SACRIFICIAL SHIELD WALL

Docket # 50-397
Control # 8007310013
Date 7-11-80 of Document:
REGULATORY DOCKET FILE

CONCERN NO. 1 NARRATIVE

STRUCTURAL REPAIR AT INTERFACE EL. 541'5"

CROSS SECTION OF SAC. SHIELD WALL
AT INTERFACE

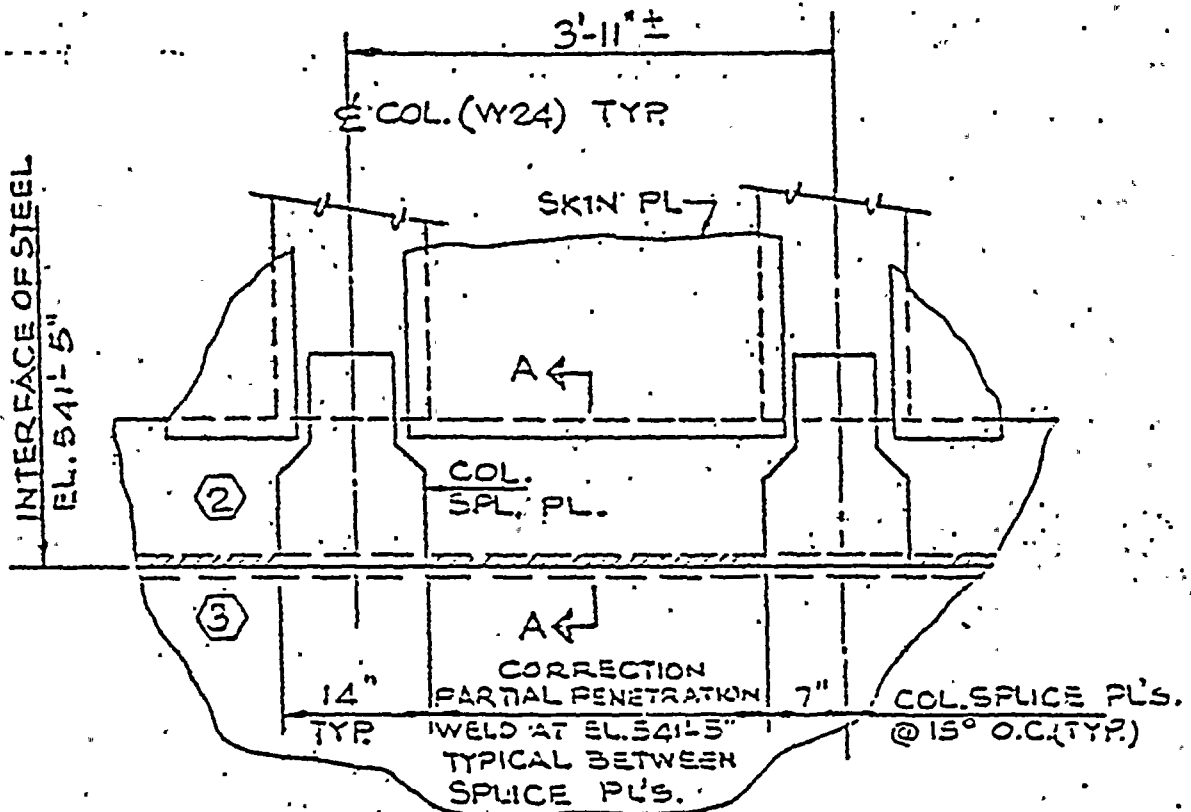
THE SPECIAL REQUIREMENTS FOR SHEAR TRANSMISSION AT THE INTERFACE AT EL. 541'5" FOLLOW FROM THE METHOD OF ERECTION OF THE SHIELD WALL. AS WAS NOTED IN THE PREVIOUS TALK, THE SHIELD WALL WAS ERECTED IN TWO PHASES WITH THE INTERFACE AT EL. 541'5" SEPARATING THE UPPER AND LOWER PORTIONS.

- o AS SEEN IN THE CROSS SECTION, THE INTERFACE LIES BETWEEN UPPER CHANNEL 2 AND THE LOWER BOX BEAM 3.
- o THE CONTRACT PROVIDED FOR TRANSMISSION OF HORIZONTAL SHEAR BY SLOT WELDS IN CHANNEL WEB JOINING THE BOX BEAM.
- o AS INDICATED IN THE PLAN, 4 SLOT WELDS WERE PROVIDED IN THE VICINITY OF EACH OF THE 24 WF COLUMNS WHICH JOIN THE CHANNEL FROM ABOVE.
- o IN ORDER TO PLUMB THE UPPER PORTION OF THE WALL ABOVE EL. 541'5", SHIMS WERE PLACED BETWEEN MEMBERS 2 AND 3. THEN, IN MANY CASES THE SLOT WELDS THROUGH THE CHANNEL WEB WERE MADE TO THE SHIMS INSTEAD OF TO MEMBER 3. THUS, THE CONTRACT REQUIREMENT WAS VITIATED.

PROPOSED INTERFACE CORRECTION -
ELEVATION AND SECTION

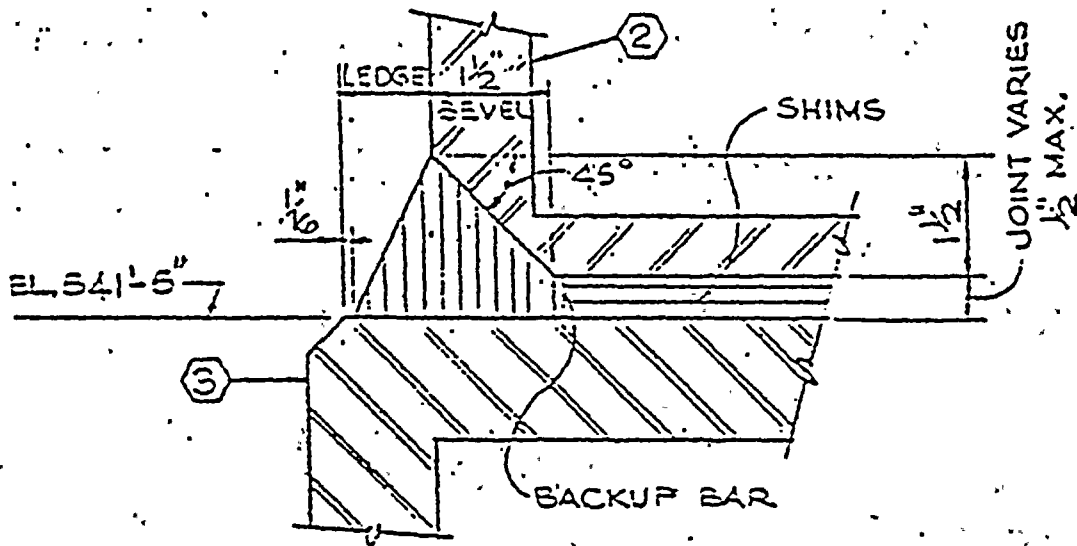
THE EXTENT AND GENERAL FEATURES OF THE CORRECTION WELD ARE SHOWN IN THESE VIEWS.

SECTION A-A, TAKEN ACROSS THE SHIELD WALL, SHOWS:

- ° CHANNEL MEMBER 2 ABOVE THE INTERFACE AND BOX MEMBER 3 BELOW THE INTERFACE.
- ° SEIM PLATES HAVE BEEN INSTALLED BETWEEN THE TWO MEMBERS UP TO A MAXIMUM THICKNESS OF 1/2 INCH.
- ° THE CORRECTION WELD IS A PARTIAL PENETRATION GROOVE WELD BETWEEN THE TWO MEMBERS.

THE UPPER VIEW IS AN EXTERIOR ELEVATION OF THE WALL.
IT SHOWS:

- ° THE INSTALLED COLUMN SPLICE PLATES WHICH JOIN THE UPPER COLUMNS TO THE BOX BEAMS BELOW THE INTERFACE.
- ° THE PROPOSED CORRECTION WELD WHICH WILL EXTEND FOR THE FULL WIDTH BETWEEN SPLICE PLATES IN EACH OF THE 24 PANELS AROUND THE WALL.

PROPOSED INTERFACE CORRECTION-DETAILS.

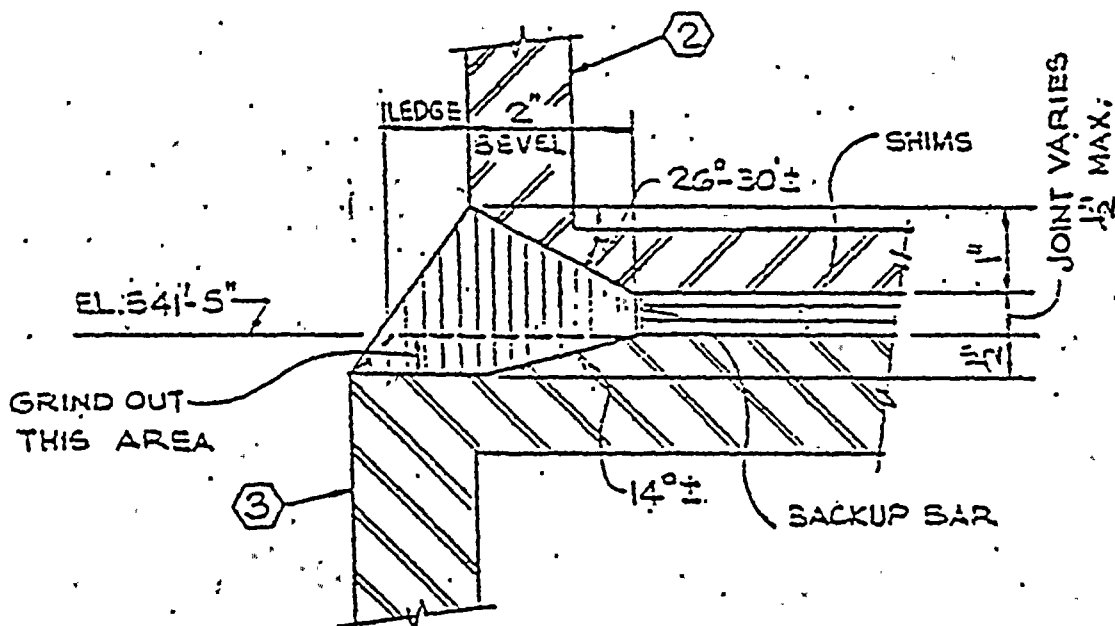
SECTION WHERE LEDGE IS A MINIMUM OF 1" WIDE

SECTION WHERE LEDGE IS LESS THAN 1" WIDE,

- HORIZONTAL SHEARS ARE TRANSMITTED BETWEEN RING CHANNEL 2 AND RING BOX 3 :
- HORIZONTAL SHEARS FROM CHANNEL 2 ARE DUE TO
 - o HORIZONTAL REACTIONS BETWEEN SKIN PLATES AND CHANNEL
 - o HORIZONTAL REACTIONS BETWEEN W24 COLUMNS AND CHANNEL
- DIRECTIONS OF SHEARS ARE
 - o TANGENTIAL (CIRCUMFERENTIAL) FROM SKIN PLATES.
 - o TANGENTIAL AND RADIAL FROM COLUMNS
- ANALYSIS IS BASED ON ONE 15° PANEL (BETWEEN W24 COLUMNS)
 - o LARGEST COMBINED SHEAR IN ANY ONE PANEL IS USED
 - o SAME CORRECTION IS APPLIED TO ALL PANELS
- WELD DESIGN
 - o WELDING PROCEDURES WILL BE QUALIFIED IN ACCORDANCE WITH REQUIREMENTS OF AWS D1.1.
 - o ALLOWABLE STRESSES ASSOCIATED WITH PARTIAL PENETRATION GROOVE WELDS ARE USED FOR CORRECTION DESIGN.

ELEVATION LOOKING @ OUTBOARD FACE
OF SAC-SHIELD WALL

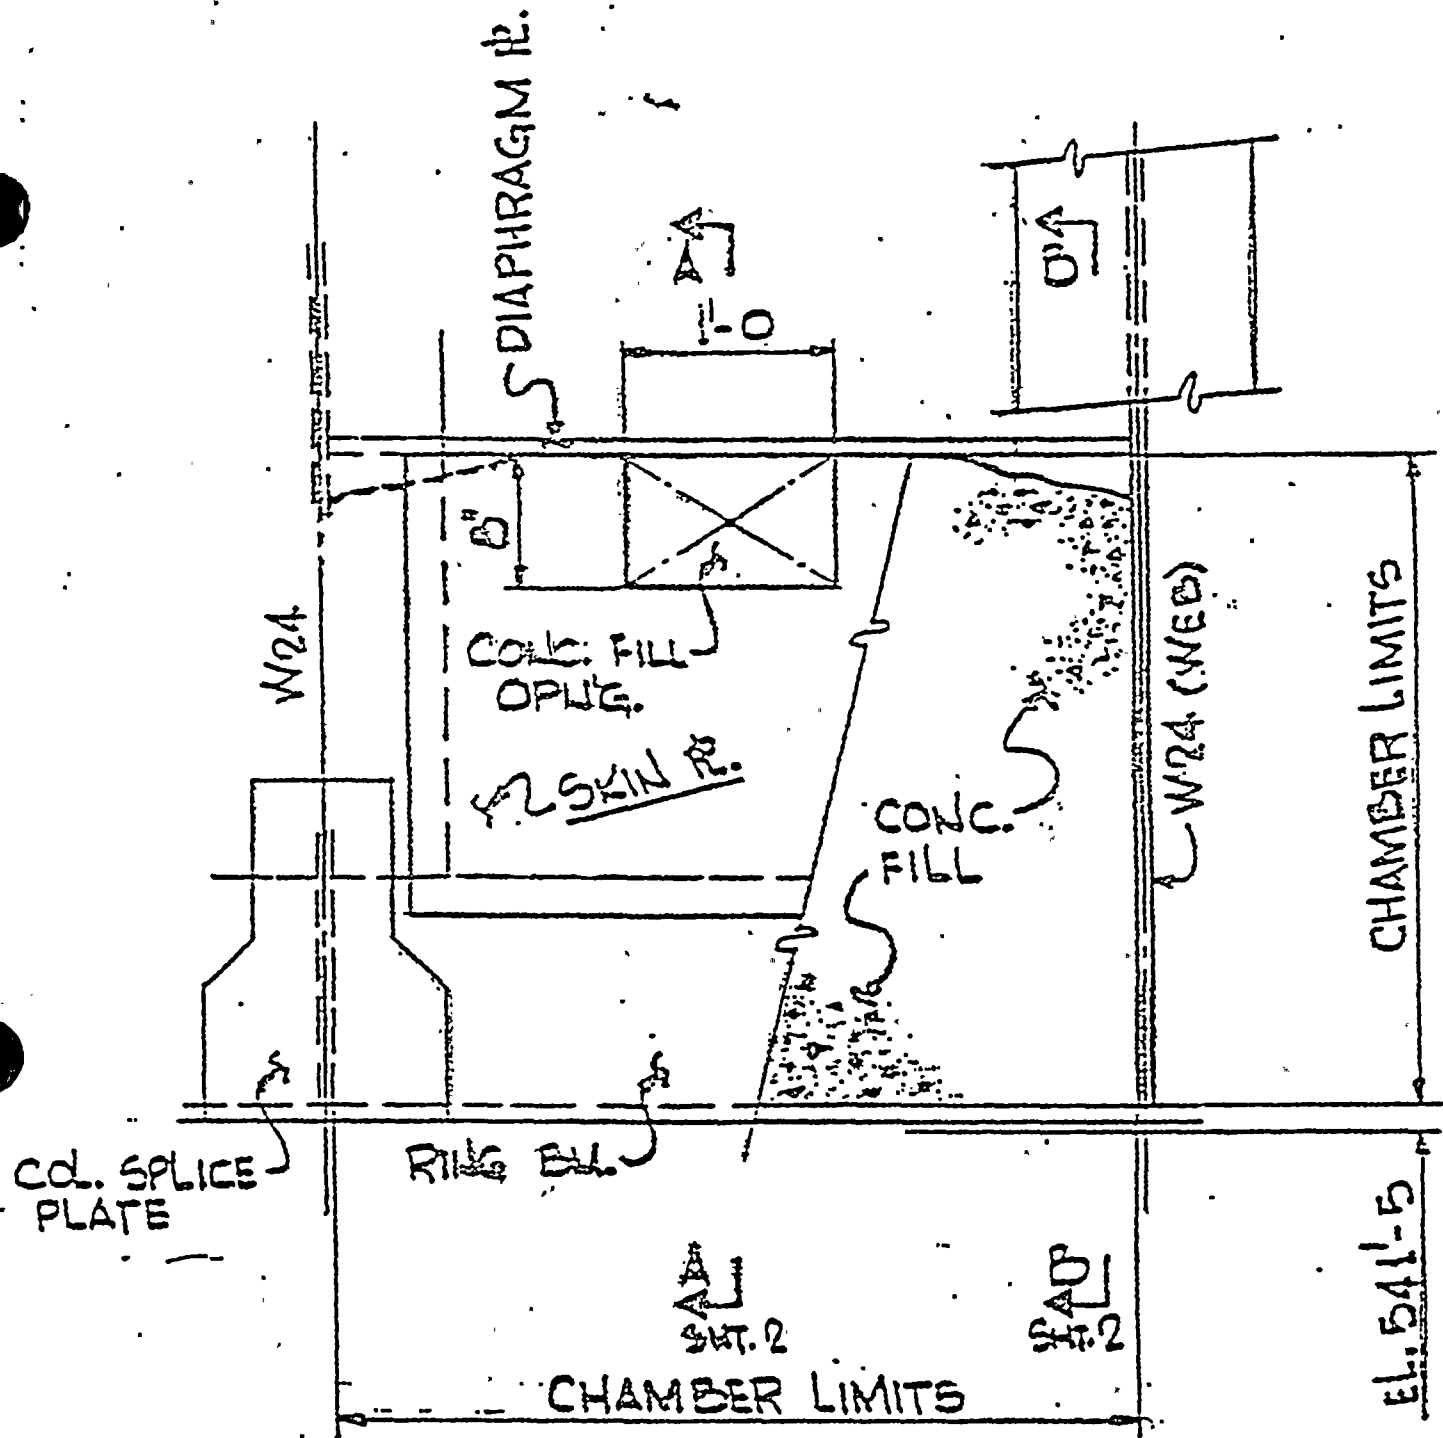
(SSW) Free water in the SSW structure - NRC RV previously understood that the existence of free water in the SSW was one isolated case. However review of 16 contract 215 IR's shows seven (7) cases (IR2525 (2 welds), IR 3069, IR 1703, 1464 (two locations), and IR 2915) where free water or moisture emanated from the SSW. It is not clear, considering the compartmented structure of the SSW, how water from an external source (i.e. weather) could be the source of all leaking welds. Need to assure water is not/wax-not detrimental (not present on back side of joint during welding).

- FREE WATER INSPECTION REPORTS (IR's)
 - TOTAL 7 LOCATIONS - ALL SKIN PLATES
 - 6 WELDS MADE PRIOR TO PLACING CONCRETE
 - 1 WELD MADE AFTER PLACEMENT
- CORRECTIVE ACTION
 - ALL 7 WELDS REPAIRED
 - ALL WINDOW PLATES INSPECTED AND REPAIRED WHERE NECESSARY

PLAN - TYP. BEAM CONN. @ SAC. SHIELD WALL
FOR W14 x 426 WITH COVER PLATES T. & B.

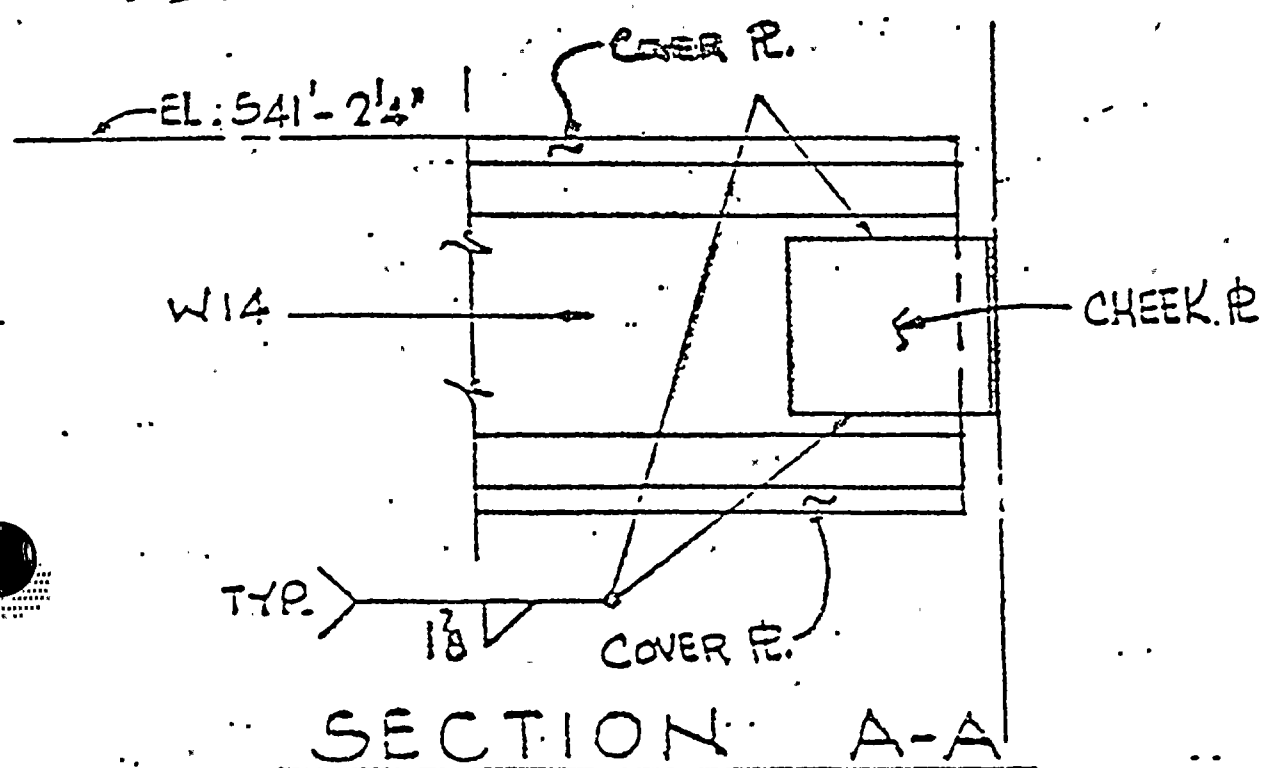
(SSW) Leckenby, as SSW fabricator, hired a consultant to determine the cause of an unusual crack in the SSW, B&R rejected the consultants determination. According to Leckenby, their consultants opinion was misunderstood by B&R. B&R has not had an opportunity to review the consultants last letter (dated June 21, 1977).

• DESCRIPTION OF CRACK

- CONSULTANTS LETTER HAS BEEN REVIEWED
- THEORIES OF CAUSE OF CRACK DISPUTED
- BEAMS AFFECTED WERE CORRECTED -
SUBSEQUENT BEAMS WERE WELDED
SUCCESSFULLY WITH REVISED WELDING
SEQUENCE & PROCEDURE.
- FURTHER ACTION - NONE REQUIRED
